REMARKS

APPENDIX A - DRAWINGS

Fig. 5

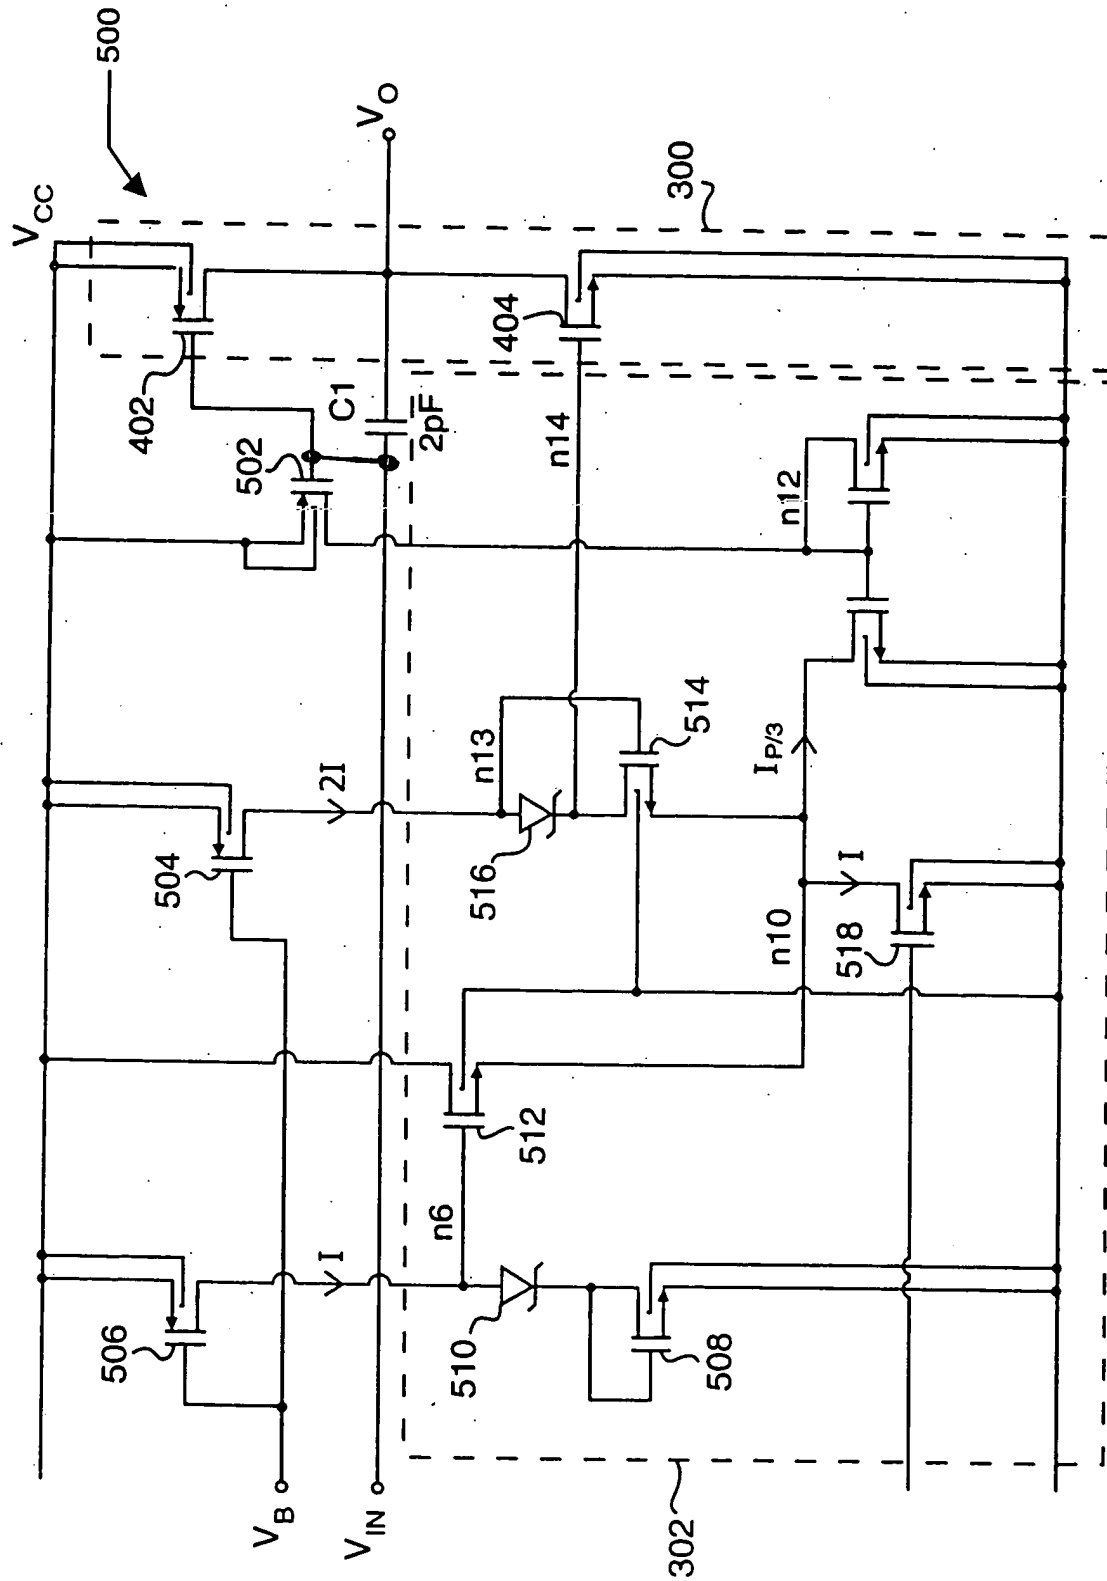
The drawings were objected to because the schematic shown in figure 5 does not appear to correspond to the block diagram of figure 4. Specifically, the output sink network 302, as shown in figure 4, is coupled to V_{IN} while the output sink network 302 as shown in figure 5 is not directly coupled to V_{IN} . Applicant respectfully traverses.

However, a review of figure 5 revealed that the gates of transistors 502 and 402 need to be coupled to V_{IN} in order for the output stage 500 to function properly. Otherwise, the gates of transistors 402 and 502 are floating. As such, an annotated sheet showing changes as well as a replacement page of figure 5 can be found at Appendix A of this paper.

As stated on page 8, line 17 of the specification, "figure 5 is a schematic of an output stage 500, *in accordance with one aspect of the present invention,*" (emphasis added). Conversely, figure 4 depicts an output stage 400. In other words, figure 5 is not an expanded schematic of the block diagram of figure 4, as figure 4 depicts an output stage 400 and figure 5 depicts an output stage 500. Therefore, the output sink network 302, as shown in figure 5, is not meant to be coupled to V_{IN} as it is shown in a different embodiment than the one shown in figure 4.

Withdrawal of the drawing objections and entry of the replacement figure 5 are respectfully requested.
